**JARED**  
JEWELERS  
STORE # 0467

# Response(s) to SPI-12 Development Review Committee

**1. Proposed Development Address: 3465 Tower Place (Jared's)**

**Project Scope:** The applicant is returning to the DRC for a first look at resubmitted plans for a jewelry store on the site of the now demolished Wells Fargo bank branch location. The existing building was demolished without required approvals which triggers the application of all code requirements as it exceeds the 60% development threshold.

1 SAP ELEVATION - WEST (LENOX ROAD NE)  
SCALE: 3/16"=1'-0"

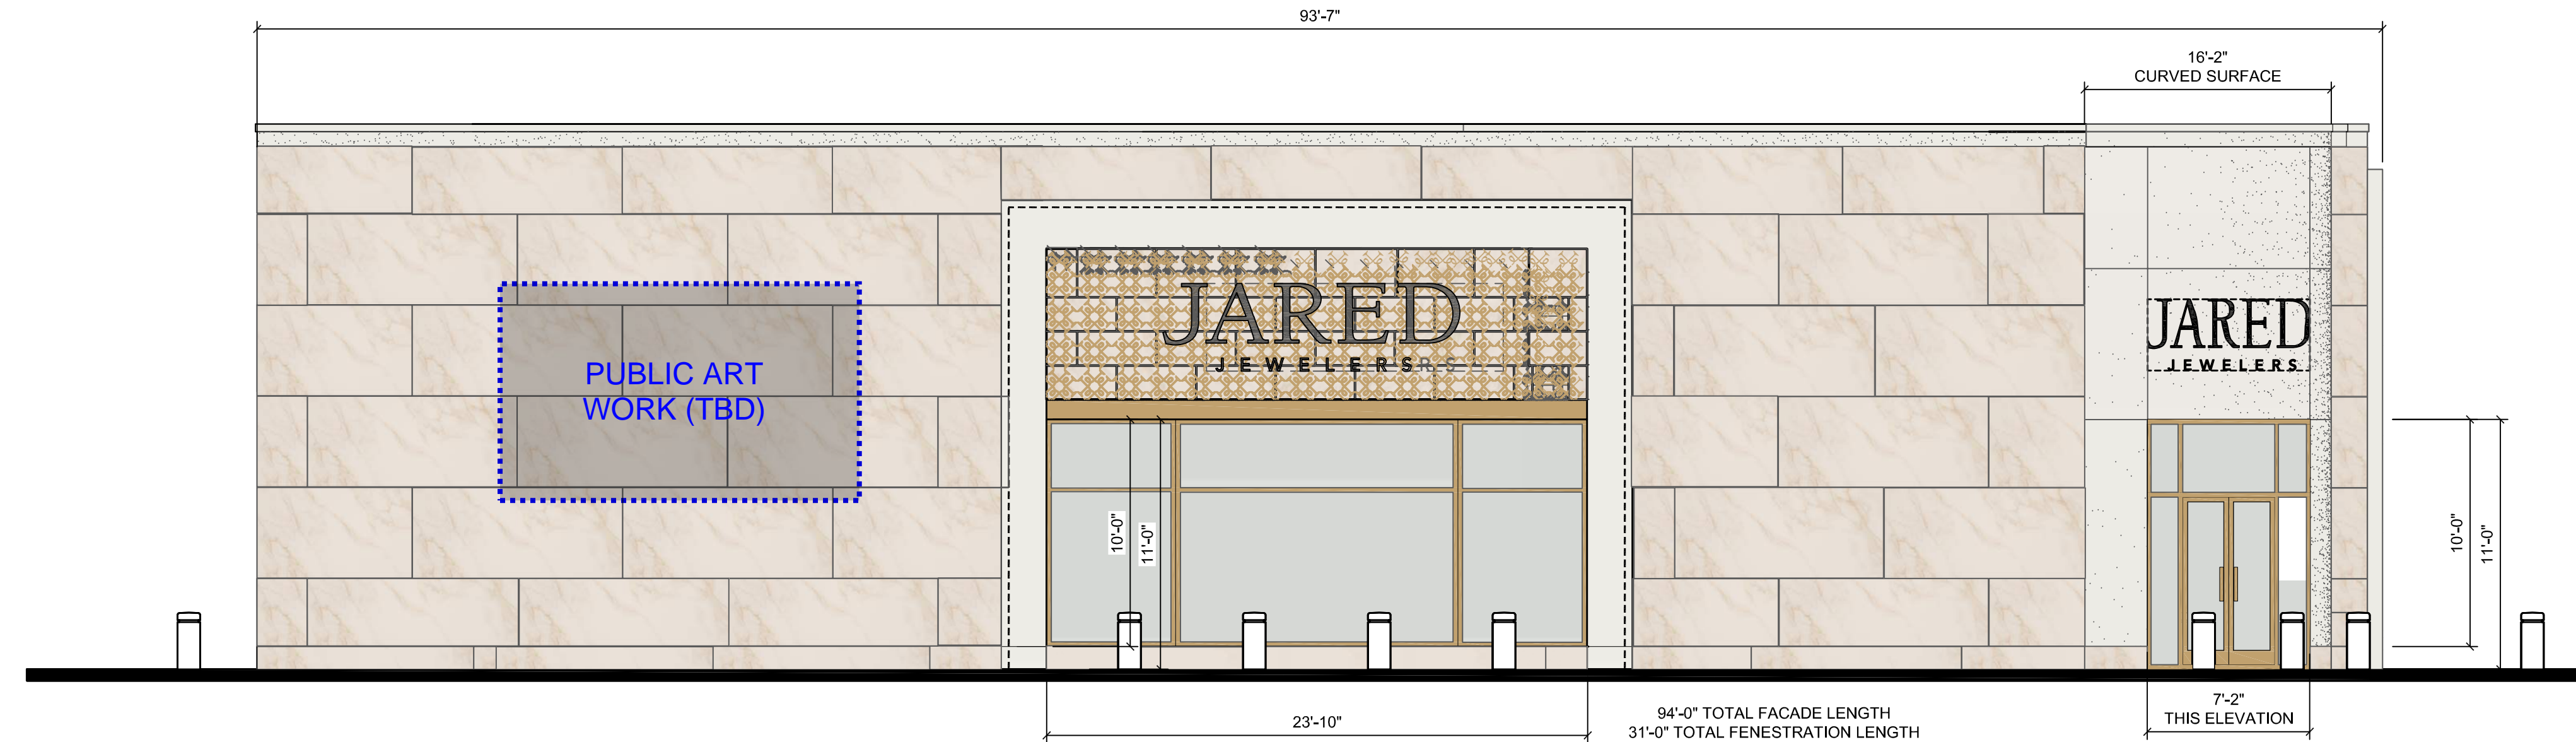
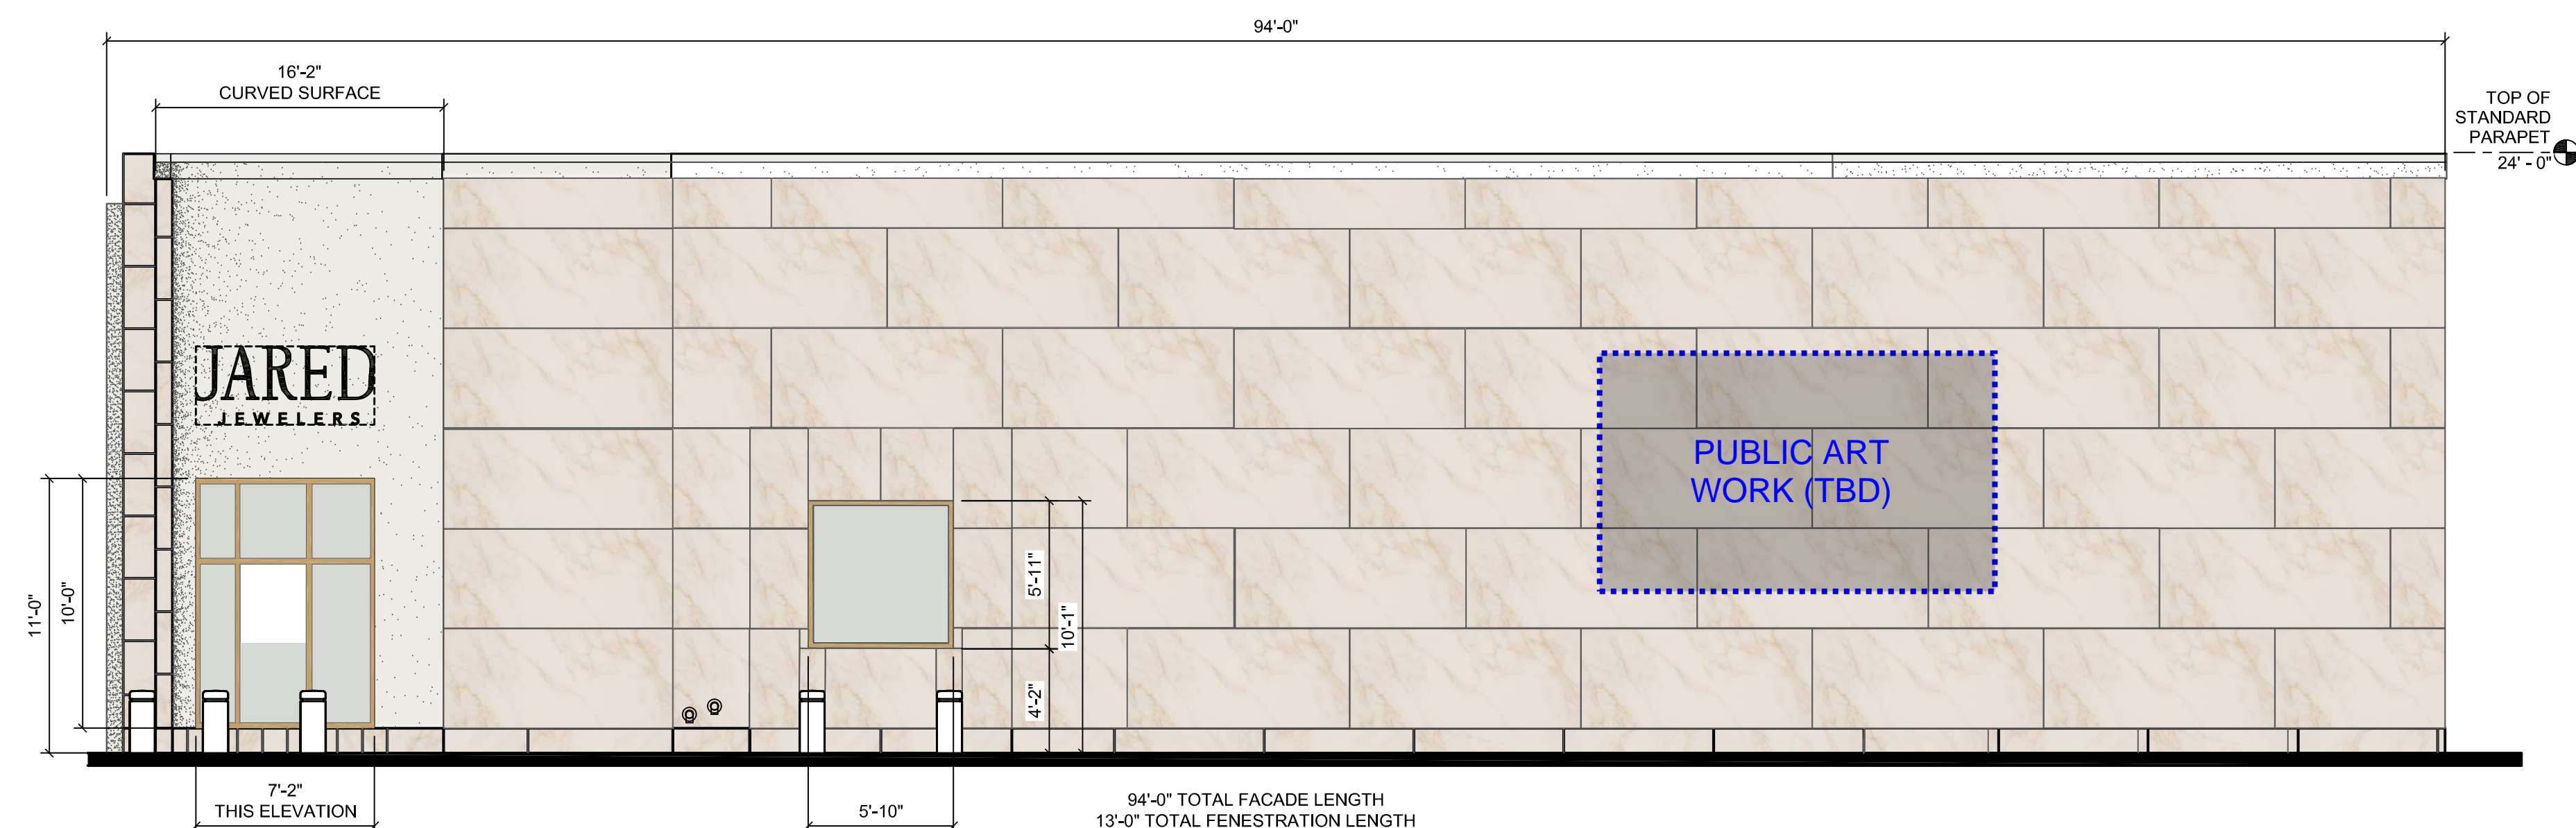
The proposed project has many stretches of façade that exceed 20’ in length. The applicant should add windows or window display cases to a greater extent than currently proposed. If fenestration is a challenge due to the business model, the applicant should consider exterior applications, such as artwork, that provide an inviting pedestrian experience.

**Sec. 16-18L.011.2.a.iii. Fenestration shall be provided for the horizontal length of the primary sidewalk-level façade as listed below for the following street types:**

**Sec. 16-18L.011.a. Peachtree Road and primary streets: A minimum of 65 percent. b. All other streets (including pedestrian ways): A minimum of 50 percent.**

The project should meet the 50 percent fenestration requirements along Tower Place frontage to reflect its role as the primary street and with the most pedestrian activity.

There should be an entrance facing Tower Place. Multiple committee members and city staff expressed a desire that an entrance be present there to better activate the pedestrian frontage for those approaching or passing by on the sidewalk side of the store.

The southwest frontage along the sidewalk and drive between Buckhead Church and the store should also meet the 25% fenestration requirement.

79'-6" TOTAL FACADE LENGTH  
21'-8" TOTAL FENESTRATION LENGTH  
REQUIRED FENESTRATION = 25%  
PROVIDED FENESTRATION = 21'-8" / 79'-6" = 27.0%

79'-6" TOTAL FACADE LENGTH  
41'-6" TOTAL FENESTRATION LENGTH  
REQUIRED FENESTRATION = MIN 50%  
PROVIDED FENESTRATION = 41'-6" / 79'-6" = 52.2%

94'-0" TOTAL FACADE LENGTH  
31'-0" TOTAL FENESTRATION LENGTH  
REQUIRED FENESTRATION = MIN 25%  
PROVIDED FENESTRATION = 31'-0" / 94'-0" = 33.0%

94'-0" TOTAL FACADE LENGTH  
13'-0" TOTAL FENESTRATION LENGTH  
REQUIRED FENESTRATION = 0%  
PROVIDED FENESTRATION = 13'-0" / 94'-0" = 13.8%

**Response:** Additional fenestration has been added. Please refer to plans for calculations.

**Response:** Additional fenestration has been added. Refer to plans for calculations.

**Response:** Additional fenestration has been added. Refer to plans for calculations.
